UPDATED FIGURE **3.0-11**

UPDATED FIGURE 3.0-16

UPDATED FIGURE 3.0-17

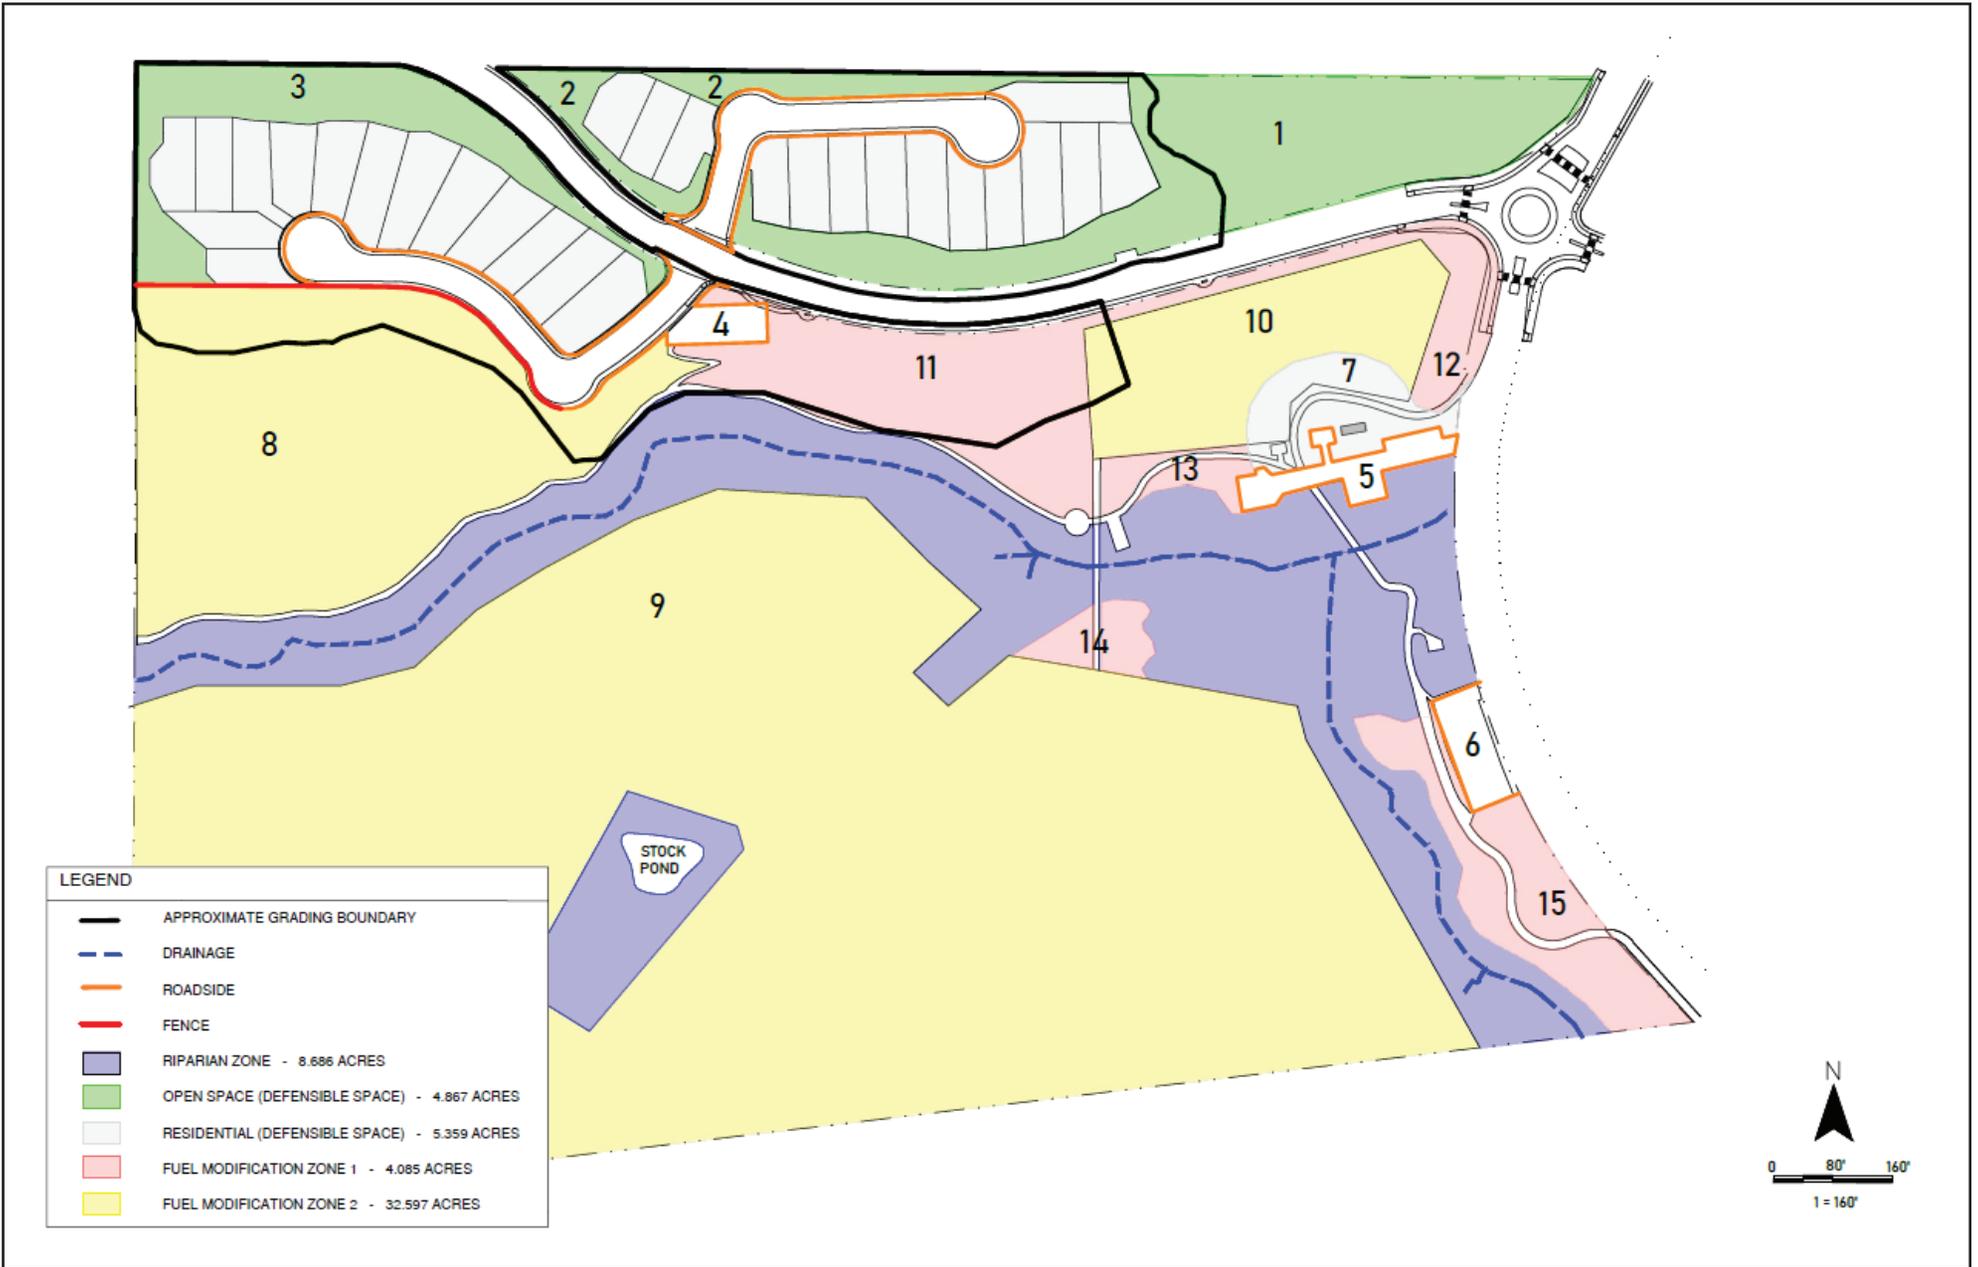
- Open Space Defensible Space Zone (green)
- Roadside Vegetation Management Zone (~~orange~~ boundary line blue)
- Fuel-Modification Zone 1 (~~yellow~~ tan)
- Fuel Modification Zone 2 (~~tan~~ yellow)
- Riparian Zone (purple)

The **Roadside Vegetation Management Zone** consists of vegetation near roads, driveways and parking lots, and is designed to assist evacuation and emergency vehicle access and to limit ignitions from vehicles. It is shown in ~~blue~~ an orange boundary in **Updated Figure 3.0-16** (Areas ~~4, 5, and 6-8,~~ and 10) and also applies along Streets A and B. The standards and actions to comply with both the Residential Defensible Space/Landscaping Zone and the Roadside Vegetation Management Zone are the same, with one exception. in the Roadside Vegetation Management Zone there must also be a 15-foot vertical clearance created by tree-trimming over pavement along the entire length of the roadway, parking lot, or driveway.

**Fuel Modification Zones 1 and 2** encompass the remainder of the open space portion of the project site, and ensure the fuels do not exacerbate fire hazards to adjacent landowners and structures. Fuel Modification Zone 1 (~~tan~~ yellow) is within the ~~fenced cattle grazing area~~ portion of the proposed Helen Putnam Park Extension where any cattle grazing is most likely to occur and is designed to limit fire intensity and spread by means of the pruning of trees, reduction of understory plants, and use of prescribed grazing activities. Fuel Modification Zone 2 (~~yellow~~ tan) is also within the proposed Putnam Park Extension Project component, but is outside the ~~regular~~ most likely cattle grazing area;

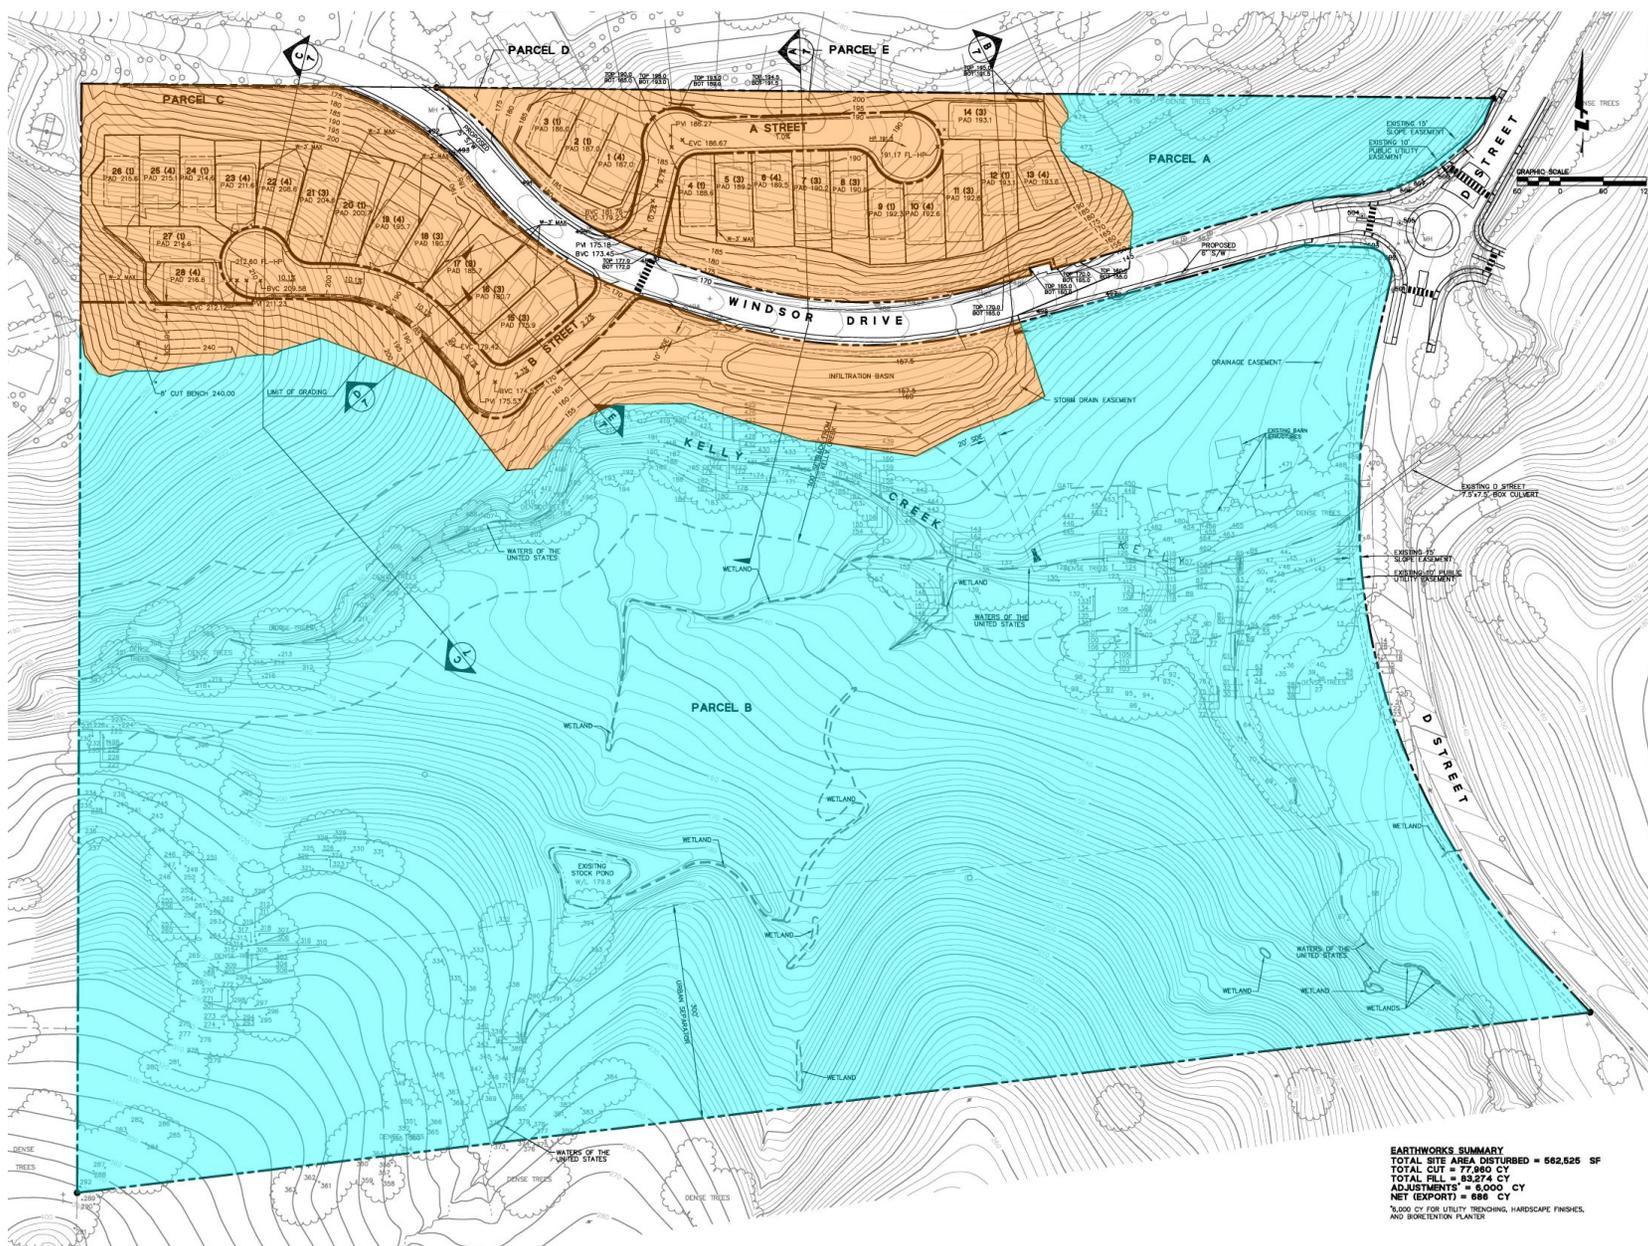
Subsequent construction phases would include building construction, completion of exterior improvements, and installation of landscaping. **Updated Figure 3.0-17, Limits of Disturbance - Davidon [28-Lot] Residential Project Component**, shows the limits of ground disturbance associated with the Davidon (28-Lot) Residential Project Component.

Site clearing, grading, and trenching for the Davidon (28-Lot) Residential Project component is anticipated to last for ~~nine~~ seven months, while construction of the residences is expected to take about 21 months, for an overall construction period of approximately ~~30~~ 28 months.
